RE: Sundance Resubmittal (DD9708)

WALKSACRAMENTO has reviewed the routing for Sundance Resubmittal (DD9708) and we offer the following comments.

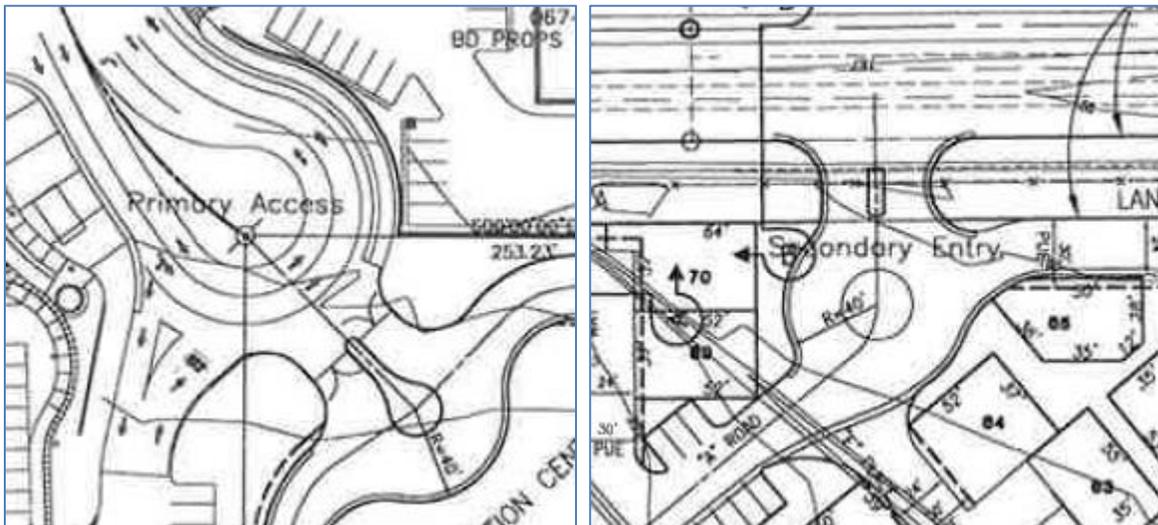
The major change to the project that would affect pedestrians is the inclusion of sidewalks on some of the private street segments. While constructing sidewalks in front of 20 of the 114 house lots will provide a safe path of travel between the two subdivision entrances, the issue of accessibility remains for the remaining 94 houses. This is because there will be a rolled curb between the driveway that will be the walkway to the house and the street that will be the walkway to everywhere else.

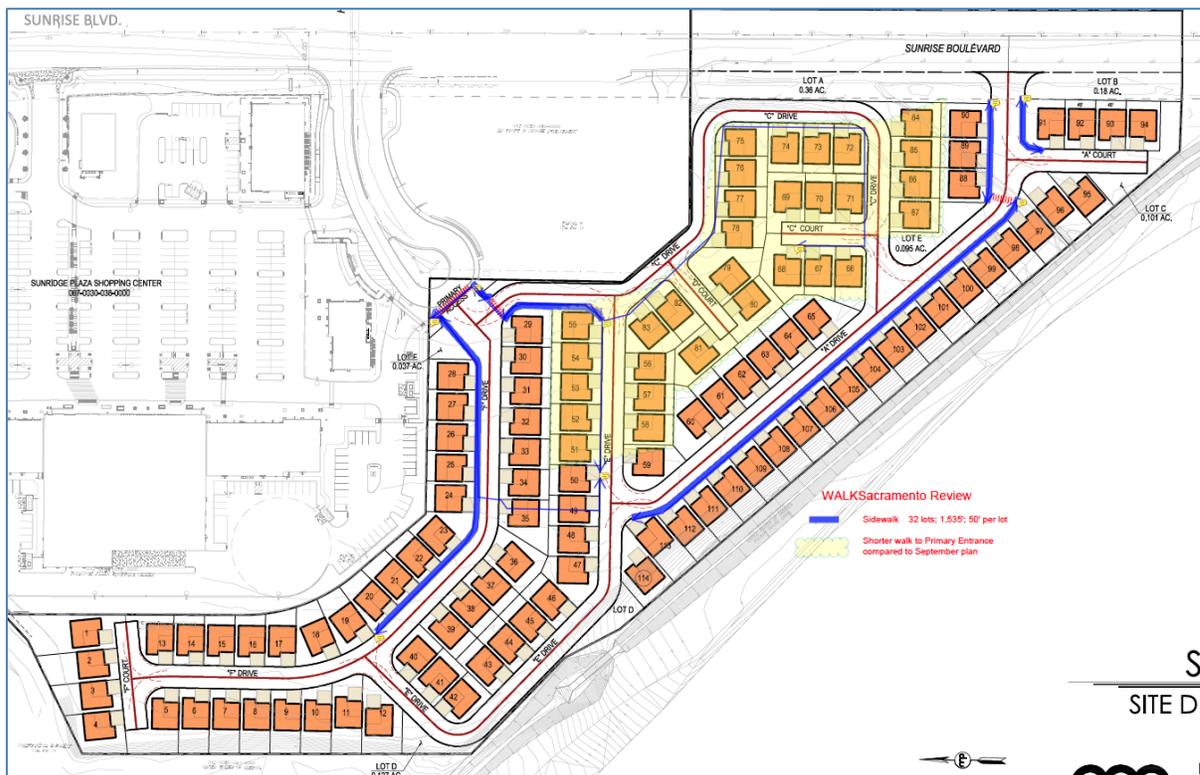
We also recommend adding a pedestrian connection through Lot A between “C” Drive and Sunrise Boulevard. This would shorten the walking distance to the commercial centers on both sides of Sunrise Boulevard for many homeowners and avoid the auto traffic entering Sundance on “A” Drive.

The original site plan, from August, appears to provide better pedestrian access than the revised plan. The splitting of the “j-shaped” block near the center of the project site and elimination of the street segment between the block and the Walgreens site creates much longer walking distances from many of the house lots to the adjacent Sunridge Plaza (Raley’s) and Walgreens shopping centers. The diagram below uses yellow shading to indicate the lots for which we believe walk distances to Raley’s would be shorter with the original plan compared to the revised plan. The blue lines show sidewalk locations. Note the long, straight section of sidewalk. This arrangement could also be incorporated in the revised plans. One benefit to this would be a significant increase in the number of houses that have sidewalks.
